CITY OF STAR

LAND USE STAFF REPORT

FILE(S) #: FP-25-04, Final Plat, Legado Subdivision Phase 2

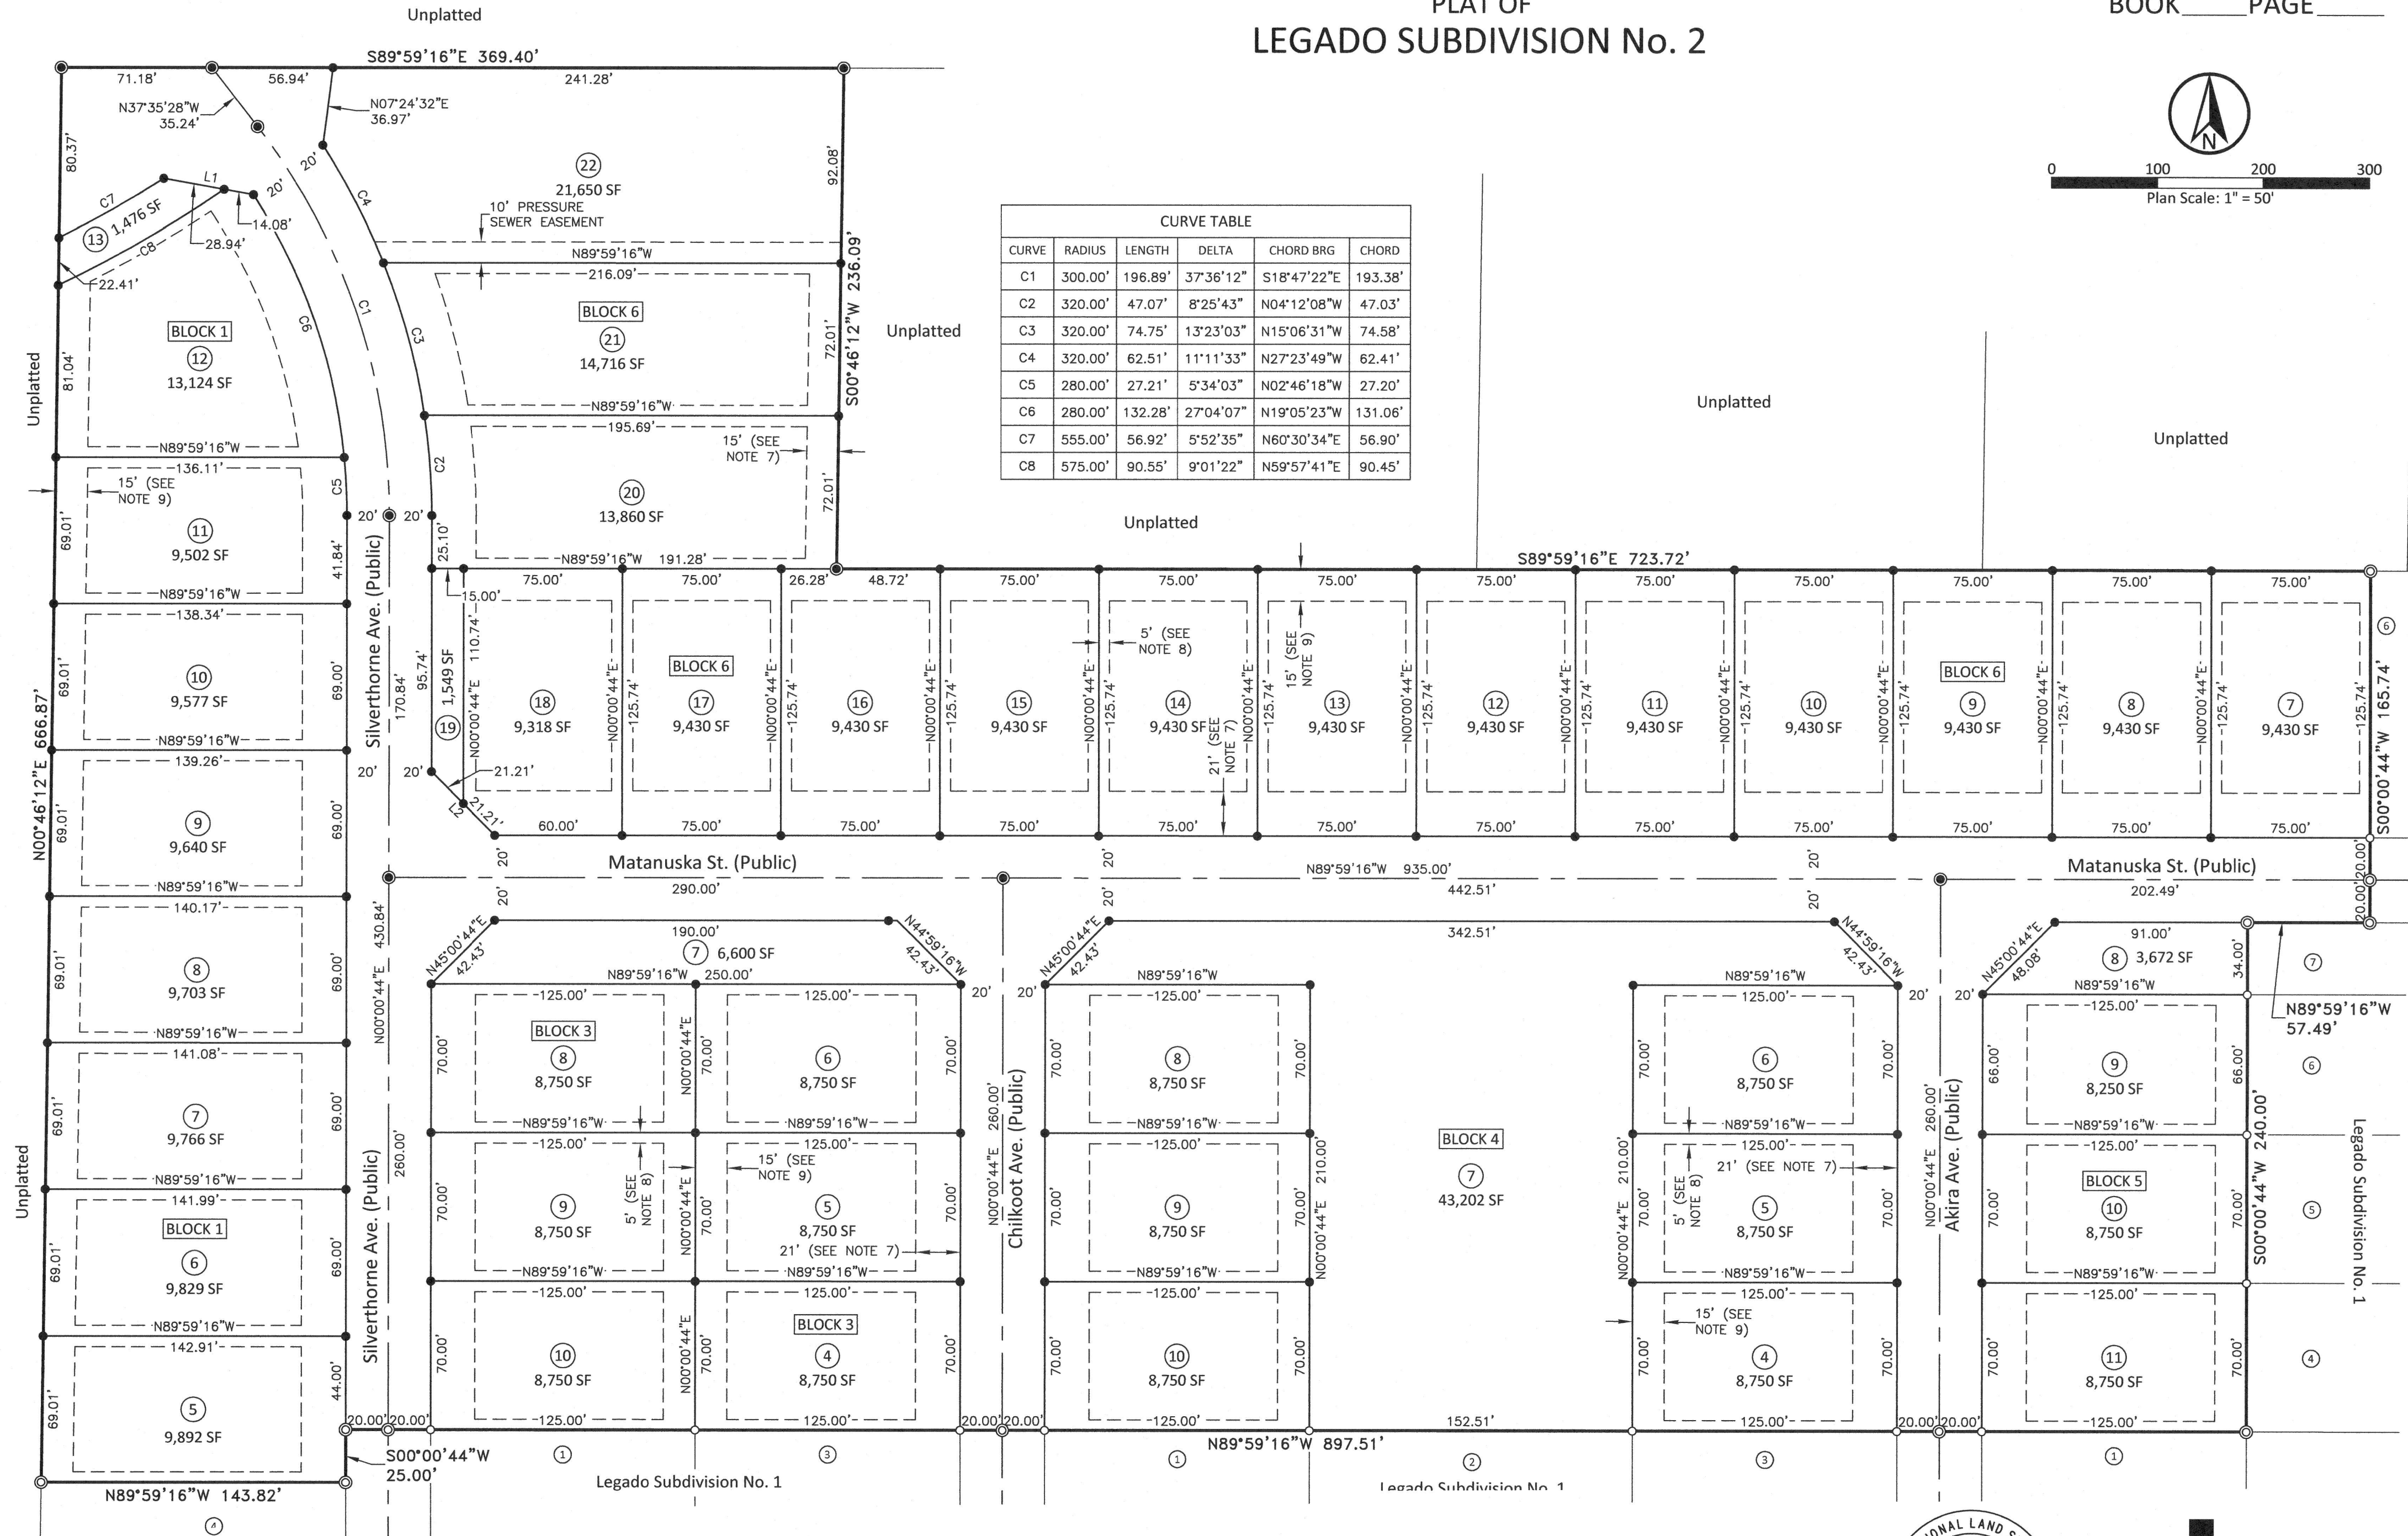
1. Revise to show 1/4 section corner and line for Section 12/13 on all plat sheets.
2. Revise sheet 2 of 4, graphic "Bar" scale doesn't match drawing or "Plan Scale" units.
3. Revise to provide a note specifying no direct lot access to Landruff Lane.

L1.0

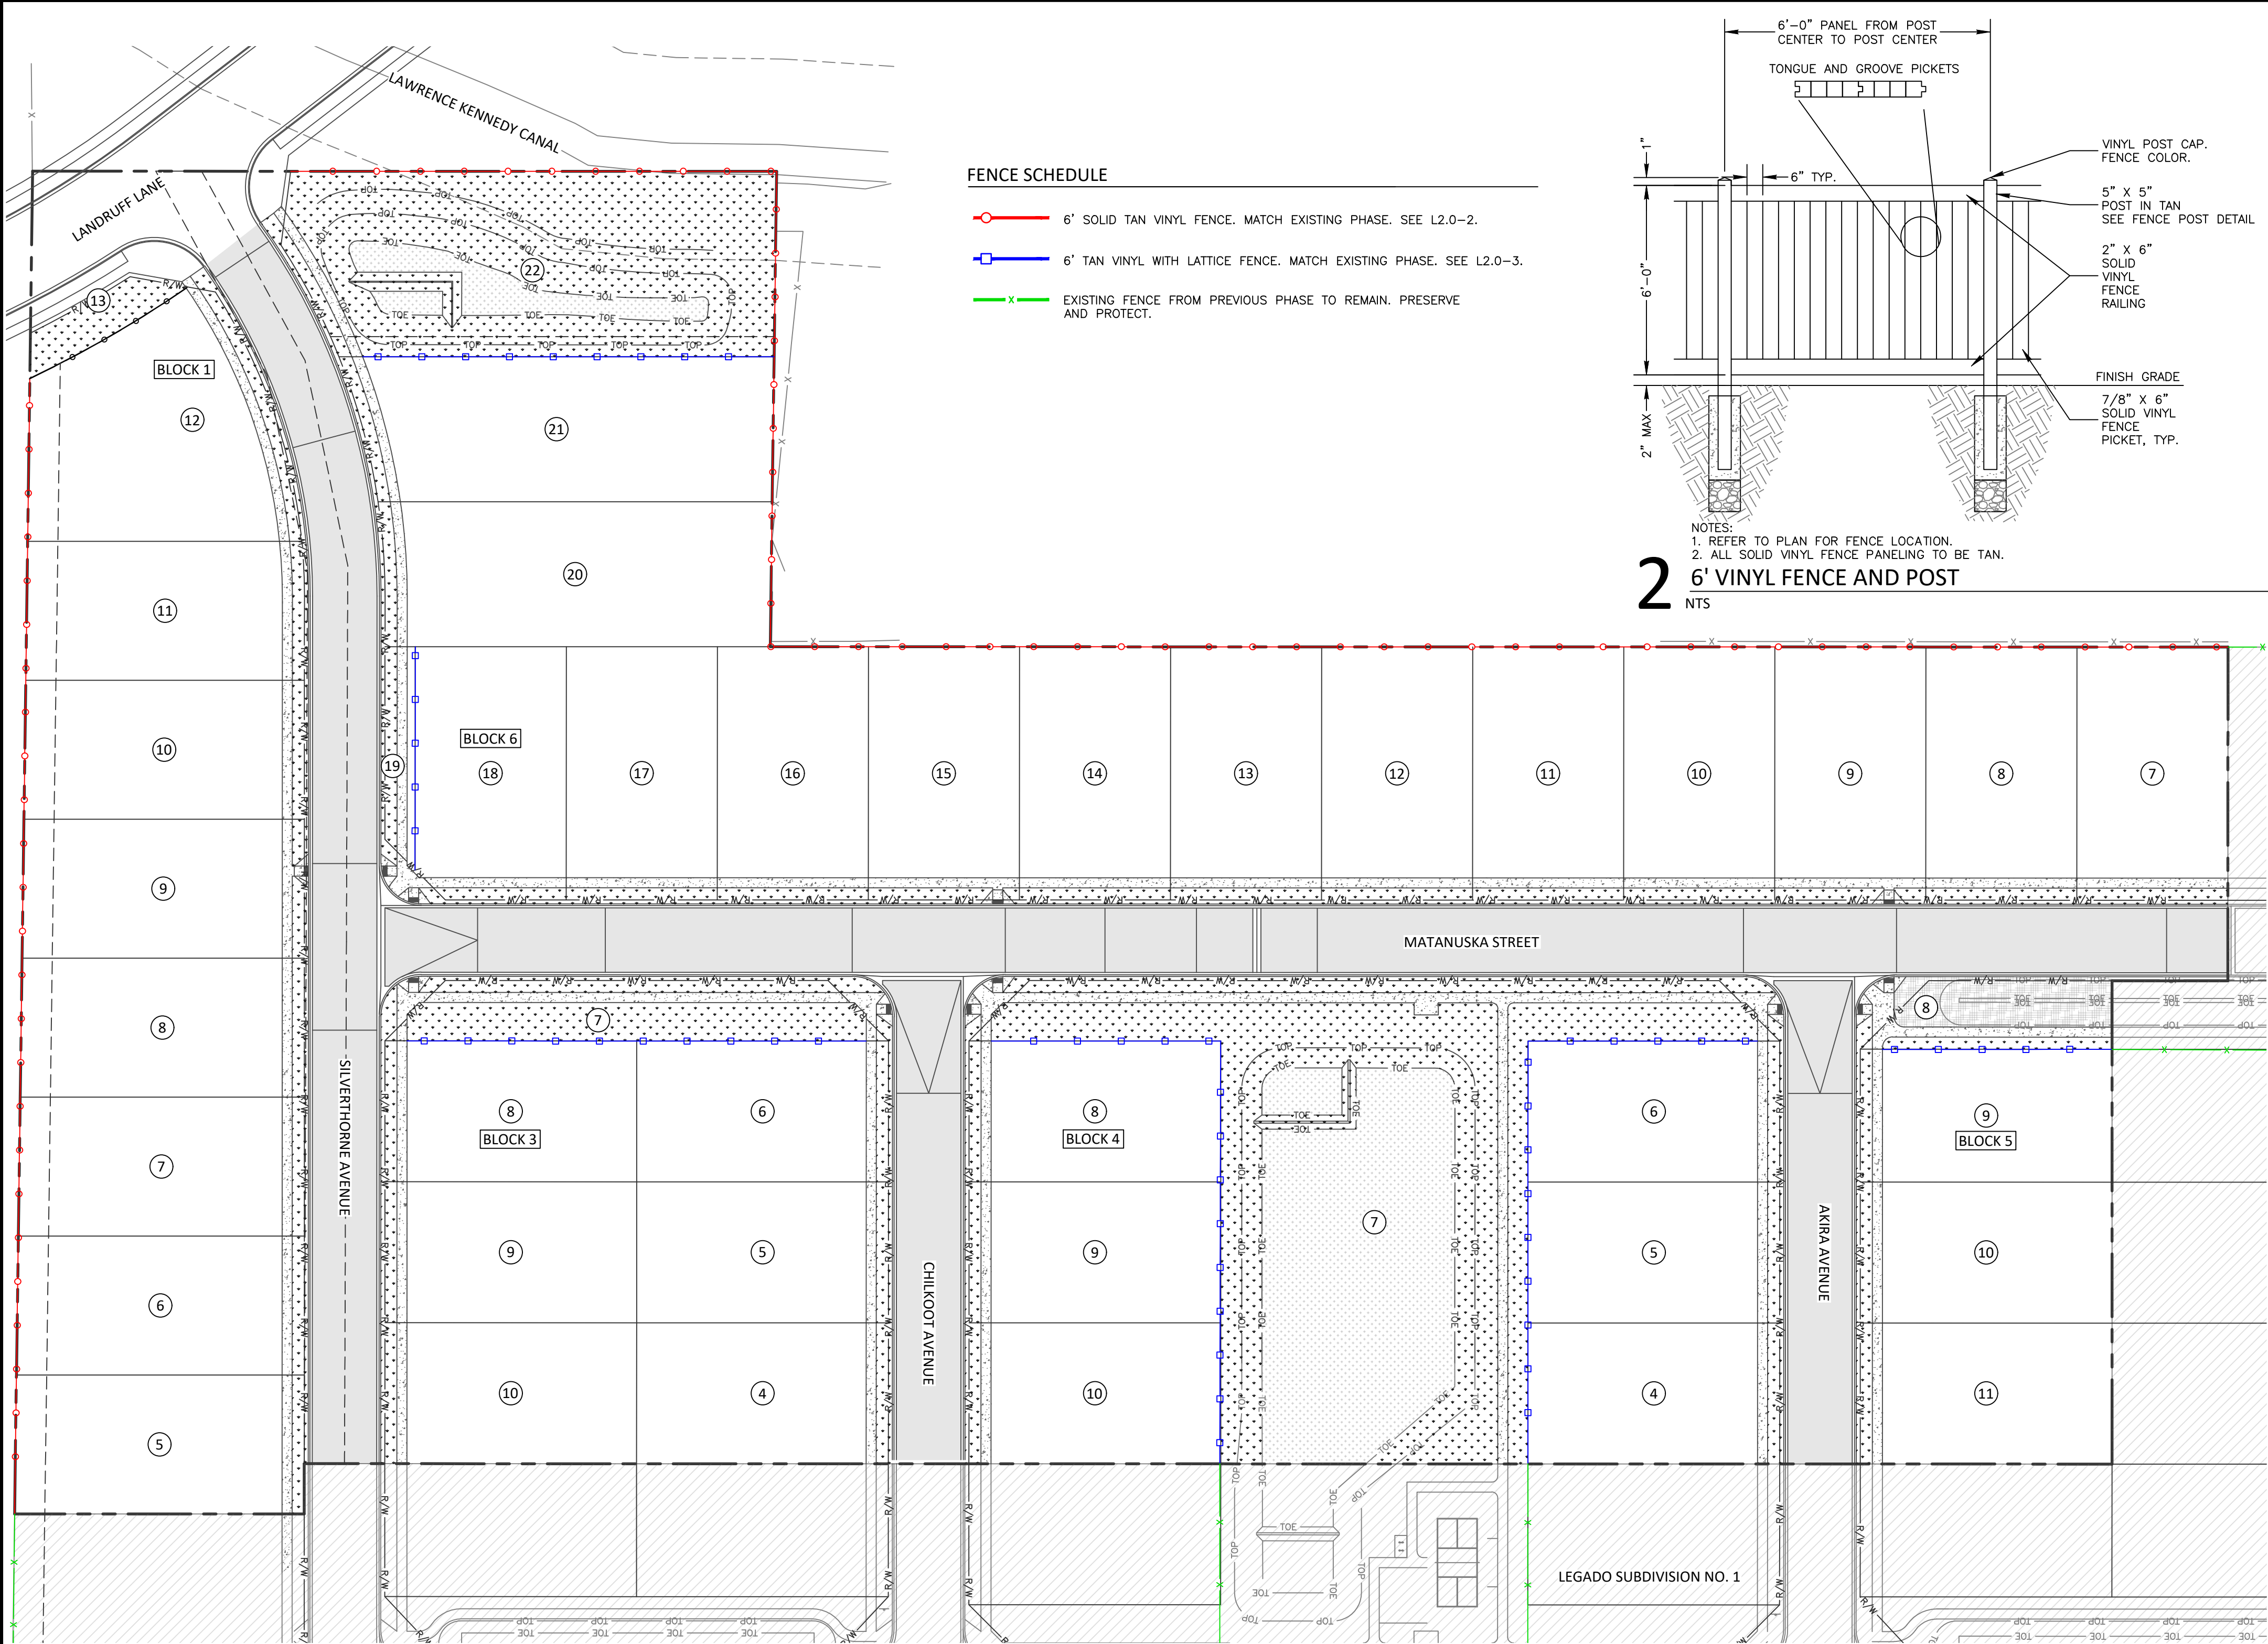
1. Revise /verify tree location, to allow driveways where "T" pedestrian crossings are proposed, coordinate with sheets C2.1 thru 2.4.
2. Revise to show 1/4 section corner monument and line for Section 12/13.
